# **Staff Recommended Changes to Draft MPSP**

On December 16, 2022, the City of Sunnyvale released the Moffett Park Specific Plan for public review. During the public review period, the City facilitated a series of meetings with the community, City Council, Planning Commission, property owners, and developers in Moffett Park. Additionally, the City received comment letters on the Specific Plan. A summary of the public meetings and links to the comment letters received by the City can be found at <u>www.moffettparksp.com</u>.

This document summarizes proposed changes to the Specific Plan in response to public comment. **This document does not contain all the proposed changes to the Specific Plan; rather it highlights key changes to the Specific Plan and describes why City staff recommend these changes.** To see a full list of comments on the Public Review Draft Specific Plan, City staff responses, and all proposed changes to the Specific Plan, please see **Appendix: Proposed Changes Matrix** for more details. City staff will also make non-policy or regulatory changes to the Specific Plan to address misspellings and typography, and to increase clarity for future readers. These chan

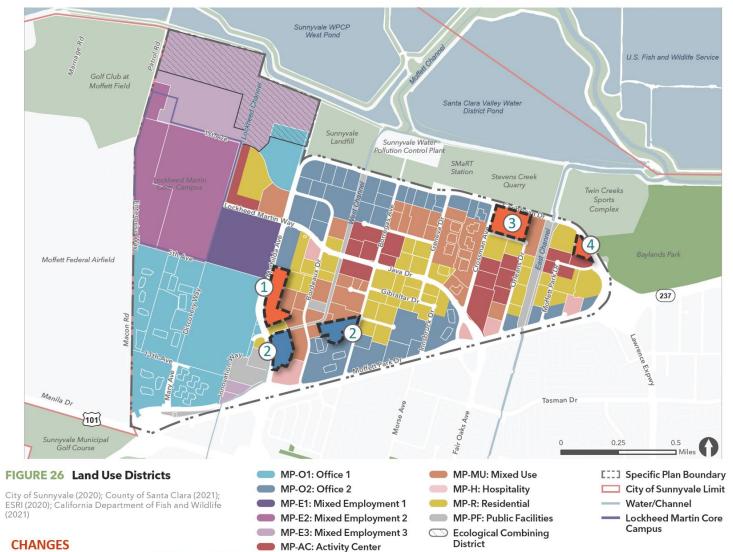
p. 81) Change **Figure 26 Land Use Districts** MP-O2 portion of APN 11037002 to MP-MU (see figure below).

Change **Figure 26 Land Use Districts** the MP-O2 portions of Commonwealth's parcels to MP-MU (see figure below).

p. 81) Change **Figure 26 Land Use Districts** MP-O2 parcels north Baltic Way to MP-MU (see figure below).

Change **Figure 26 Land Use Districts** areas of MP-MU parcels between Mathilda Avenue and Borregas Ave not adjacent to Bordeaux Dr to MP-O2(see figure below).

Figure 27(refer to Page 92 of MPSP for Figure 27): Map changes reflect flexibility in retail pattern without fundamentally changing the overall retail strategy, amount of retail, or requirements for medium format retail.

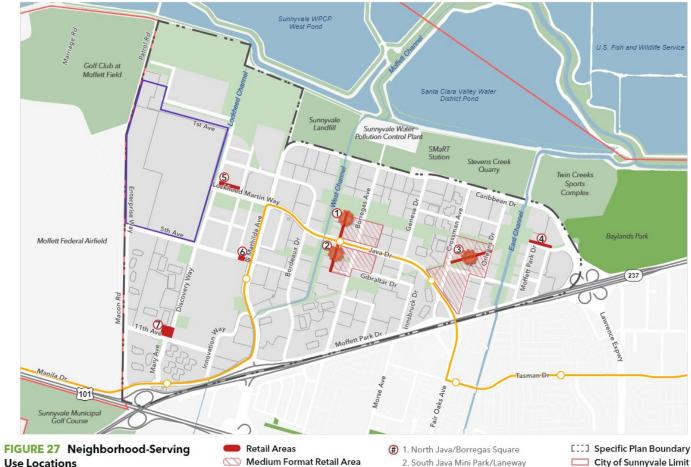
Page	Section	Background	Proposed Change
90	4.6	To provide flexibility in the location of retail while maintaining a minimum amount of ground floor retail space at key locations. (refer to Page 92 of MPSP for Figure 27)	<ul> <li>3. Neighborhood-serving retail and commercial ground floors. New development shall meet the following requirements: Frontages shall meet the following standards: <ul> <li>a. Ground floor frontage. Within North Java, South Java, and Crossman neighborhoods, a minimum 85% of building frontage identified in Figure 27 shall be retail and commercial storefronts. For other neighborhoods, a minimum 50% of building frontage identified shall be retail and commercial storefronts.</li> <li>a. Amount of Retail. Areas identified in Figure 27 shall provide the required minimum amount of floor area in retail and commercial storefronts. Storefronts shall be on the ground floor fronting public rights-of-way or open spaces and laneways with public access easements.</li> <li>North Java/Borregas Square <ul> <li>50,000 square feet; and</li> <li>15,000 square feet medium format tenant space</li> </ul> </li> <li>South Java Mini Park/Laneway</li> <li>40,000 square feet; and</li> </ul> </li> </ul>

**b. Ground floor depth.** Ground floor retail and commercial storefronts shall have a minimum depth of 25 feet and a minimum of 50% of the total frontage in each area identified in Figure 27 shall have a minimum depth greater than 50 feet. Exceptions to the minimum depth may be made for a maximum of 10% of total frontage in each area.

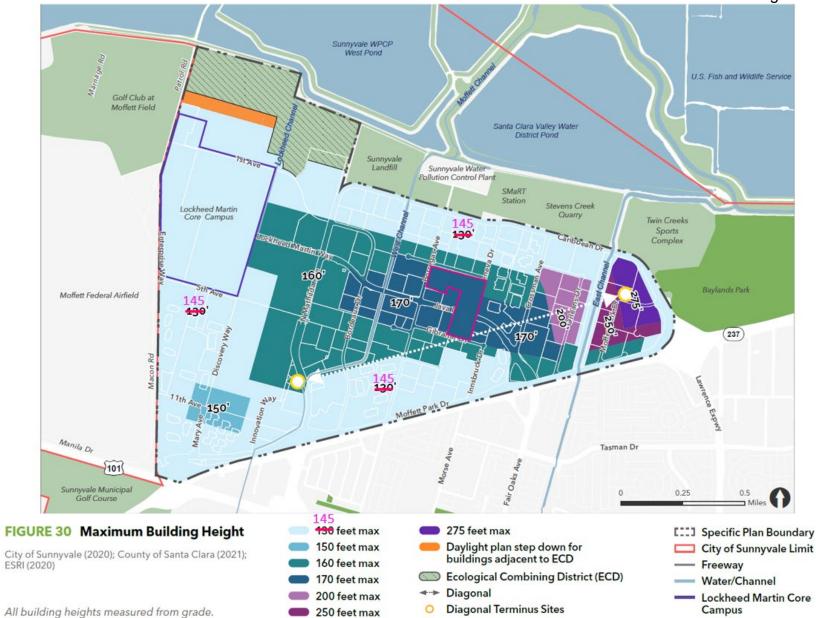
113	5.3.2	To provide more flexibility in Activity Centers, MP-R, and MP-MU districts, change dimensions for residential high-rises, clarify unclear standards, modify the high-rise buildings standards to:	Remove: All standards on page 113 Add standards: • High-rise buildings in the MP-AC districts. Applies to all portions of a building greater than 90 feet in height.

- Increase allowed building size in MP-AC district
- Change upper floor reduction in mass to provide more flexibility
- Reduce building spacing between highrises
- Increase MP-R and MP-MU residential high-rise façade length from 160 ft to 200 ft
- Change upper floor reduction in mass from above 110 ft to above 145 ft
- Change from percentage calculation to absolute maximum floor plate sizes at upper stories to provide more flexibility and more tapering at higher building heights.

- Building spacing. The portion of a building greater than 90 feet in height shall be located a minimum 60 feet from all other buildings greater than 90 feet in height regardless of whether the adjacent building is on the same parcel or different parcel. Where two adjacent parcels are under different ownership, portions of a building greater than 90 feet in height shall be located a minimum 30 feet from adjoining property line.

- Building dimensions.
  - The portion of a building greater than 90 feet in height shall not have any dimension that exceeds 250 feet in length.
- Reduction in mass.

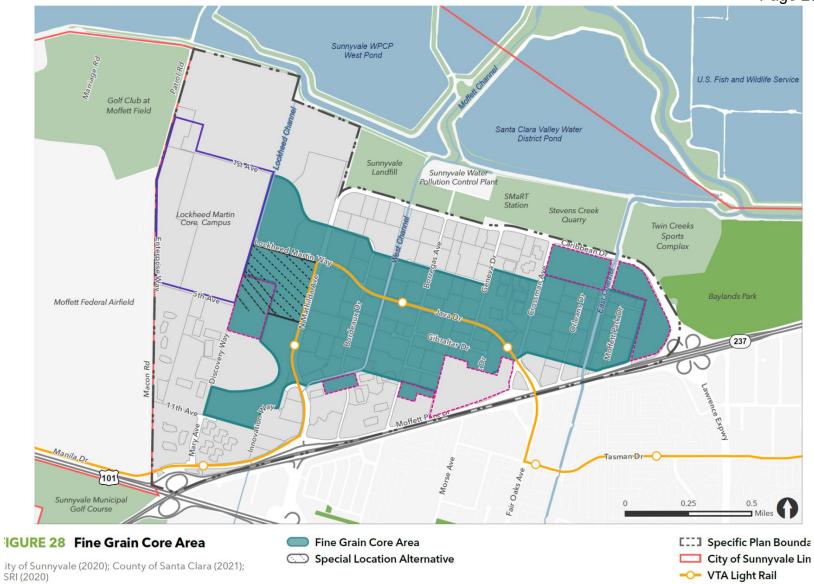
120 5.3.5 To provide more flexibility in site design

outside the fine grain core, reduce or eliminate requirements that overly restrict the development of surface parking. Surface parking in locations outside the fine grain core will not impact walkability, maximum number of spaces have been removed from the standard.

"5. Surface parking. Surface parking lots are strongly discouraged within the fine grain core. Surface parking outside the fine grain core shall minimize street frontage and shall not be located between a building and streets, laneways, and open spaces. Surface parking is allowed along Caribbean Drive. If built, surface parking shall meet the following standards:

#### **Crossman Avenue**

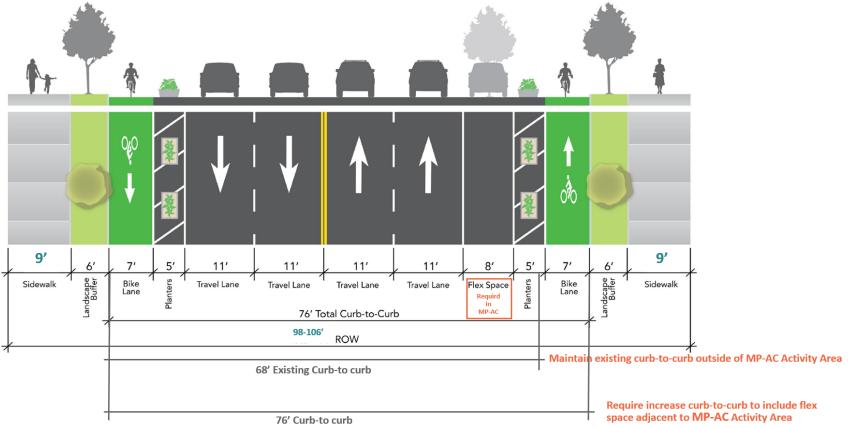
196	7.3	Change the street section for <b>Crossman</b> <b>Avenue</b> to provide clarity to implementation, identify existing curb locations, and set a standard for where the curb-to-curb dimension needs to be widened to make space for flex lanes.	Modify Figure 50 Crossman Avenue (Typical) cross section. See figure below. Modify Table 20A Curbside Zone: "8' flex space required on east side of the street adjacent to and within the Activity Center on the east side if ROW allows, available for loading or short-term parking in high-demand locations. 8' flex space optional for areas north of Activity Center to maintain existing curb-to-curb dimension."
200	7.3	To generally maintain existing curbs, modify typical sections for <b>Neighborhood Street with</b> <b>bicycle facility</b> (Bordeaux, Geneva, Orleans, and other locations where existing curb-to- curb is 43-44 feet in width) to reduce dimension. Modify bike facilities up to sidewalk level consistent with BPAC guidance.	<ul> <li>Add new section and revise Figure 54: Neighborhood Street with Bicycle Facility (Typical) See figure below. Add table with dimensions as follows:</li> <li>Curb-to-Curb: 43-44' where modifying existing street, curb- to-curb dimension may vary for new Neighborhood Streets.</li> <li>Right-of-Way: 86'</li> <li>Pedestrian Zone: 9' sidewalk; 6' landscape buffer</li> <li>Bicycle Facilities 6' Class IV separated bikeway in each direction protected by a 3' buffer.</li> <li>Vehicle Lanes: One 11' travel lane in each direction</li> <li>Curbside Zone: 8' flex space available for landscaping, loading, or short-term parking</li> <li>Medians: N/A</li> </ul>

dify Figure 50 Crossman Avenue (Typical) cross section. See figure below.

#### **Neighborhood Street with Bicycle Facility**

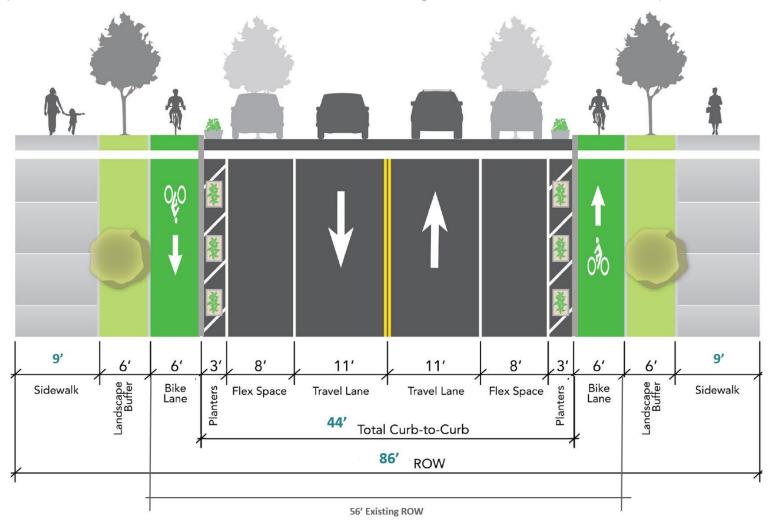
generally maintain existing curbs, modify typical sections for Neighborhood Street with bicycle facility (Bordeaux, neva, Orleans, and other locations where existing curb-to-curb is 43-44 feet in width) to reduce dimension. Modify bike lities up to sidewalk level consistent with BPAC guidance. Add new section Revise Figure 54: Neighborhood Street with ycle Facility (Typical). Revise table with dimensions as follows:

(Bordeaux, Geneva, Orleans, and other locations where existing curb-to-curb is 43-44 feet in width)

### Laneway/Shared Street

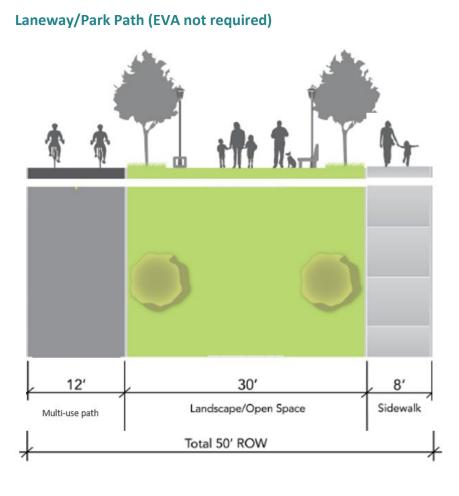
dify Figure 55 Laneway Shared Street (Typical) cross section.

\*if EVA is required, shared street may be required to be increased to 20', aerial apparatus location may include flex space for 26' area

### Laneway/Park Path (EVA Required)

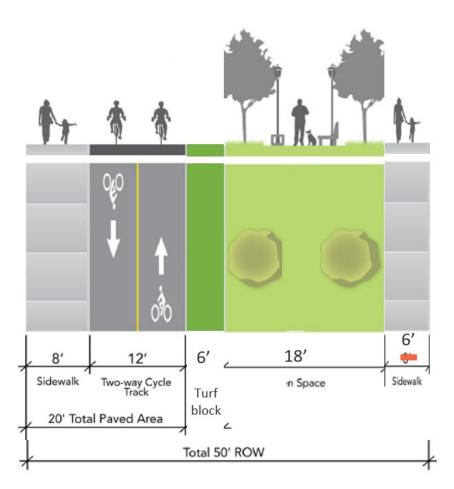
202	op dir	o simplify Laneway/Park Path design, add otions for when EVA is required, and provide rect access to ground floor units and entry ays on both sides of the laneway.	<ul> <li>Modify Figure 56 Laneway Park/Path (Typical) cross section. Add new section for Laneway. See figures below.</li> <li>Modify Table:         <ul> <li>Pedestrian Zone: Minimum of 1 pedestrian path or sidewalk on either side of laneway with minimum 6-foot width; 30' landscaped area that could accommodate furnishings, or other park amenities, landscaped area may be reduced in width to 24' to accommodate EVA</li> </ul> </li> </ul>

dify Figure 56 Laneway Park/Path (Typical) cross section. Add new section for Laneway.
